UNITED STATES PATENT AND TRADEMARK OFFICE

APPLICATION NO.	FILING DATE	FIRST NAMED INVENTOR	ATTORNEY DOCKET NO.	CONFIRMATION NO.
10/730,852	12/09/2003	Kiyonori Oyu	ELPIDA 03USFP943	5218
27667	7590	09/29/2005	EXAMINER	
HAYES, SOLOWAY P.C. 3450 E. SUNRISE DRIVE, SUITE 140 TUCSON, AZ 85718			NGUYEN, THINH T	
			ART UNIT	PAPER NUMBER
			2818

Office Action Summary

DETAILED ACTION

Fig. 2 PRIOR ART

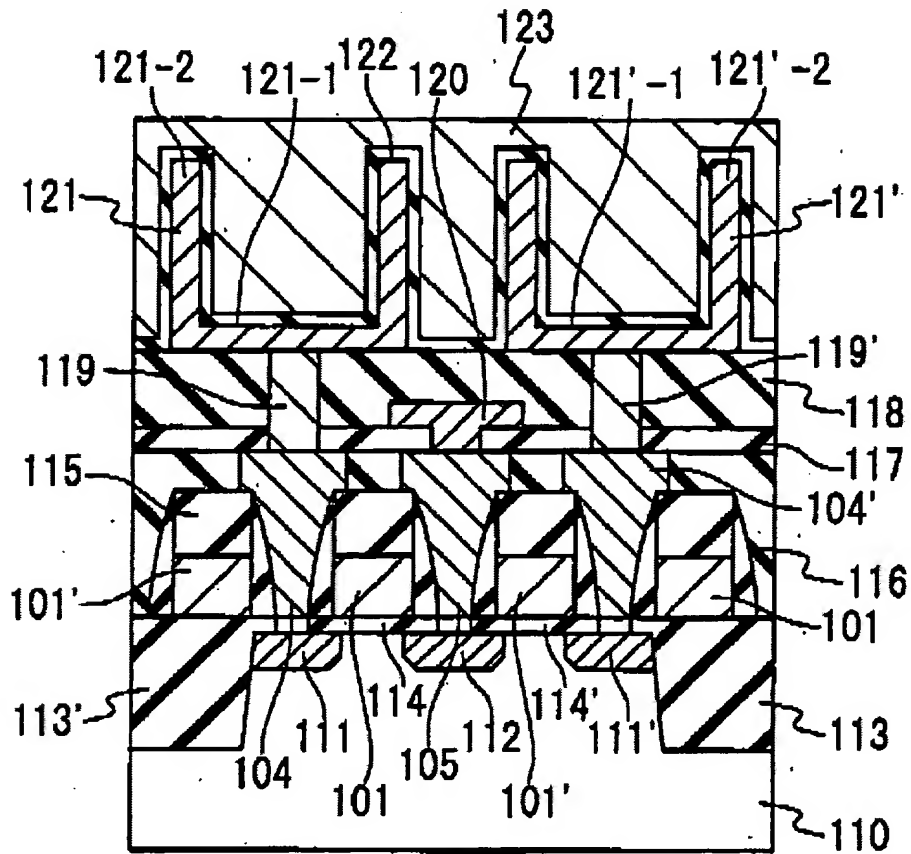
The AAPA (as shown in fig 1, fig 2, the background section of the application 0 discloses all the invention except is silent about the gate length that is longer than the processing dimension. Bronner, however (column 2 lines 52-53) discloses that a gate length longer than the processing dimension can be use to cure a leakage problem in DRAM.

It would have been obvious to one of ordinary skill in the art the time the invention was made to complement the teachings by the AAPA with the teachings by Bronner in order to come up with the invention of claim 3-4.

A person skilled in the art at the time the invention was made would have been motivated to improve the retention time of the DRAM device as suggested by Bronner in column 2 lines 52-53.

Fig. 5

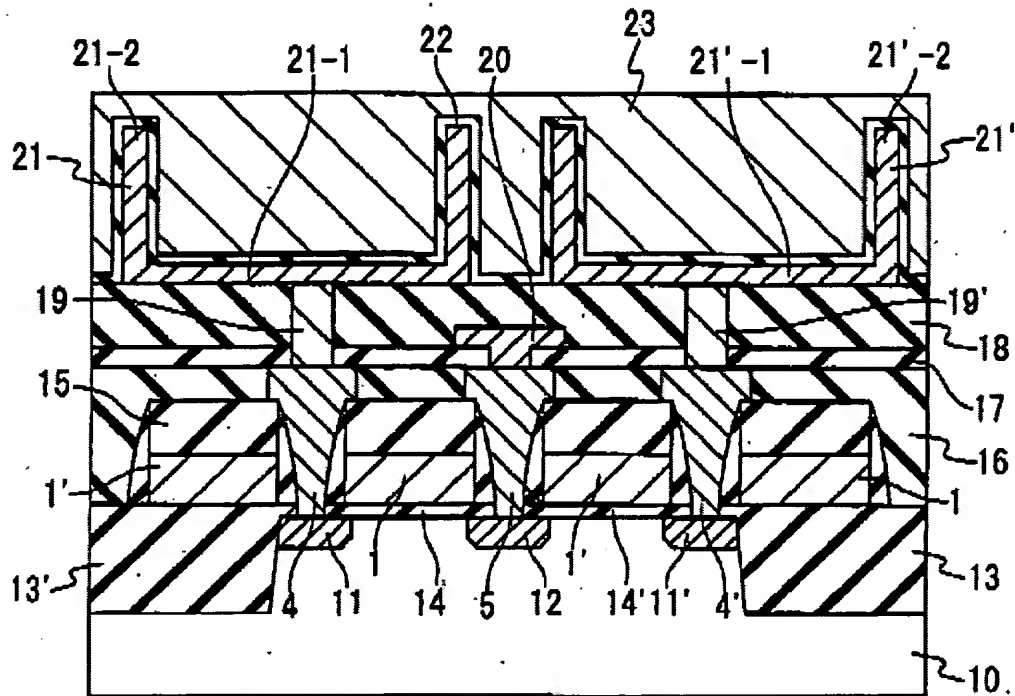
6. Claims 5-6 are rejected under 35 U.S.C. 103(a) as being unpatentable over the Applicant Admitted Prior Art in view of Bronner et al. (US patent 6,767,789) and in further view remark.

The combined teachings by the AAPA and Bronner disclose all the invention except for the side length of the first contact and the second contact. These features, however, are considered obvious since it has been held that when the general condition of a claim are

disclosed in the prior art, discovering the optimum or workable ranges involves only routine skill in the art.
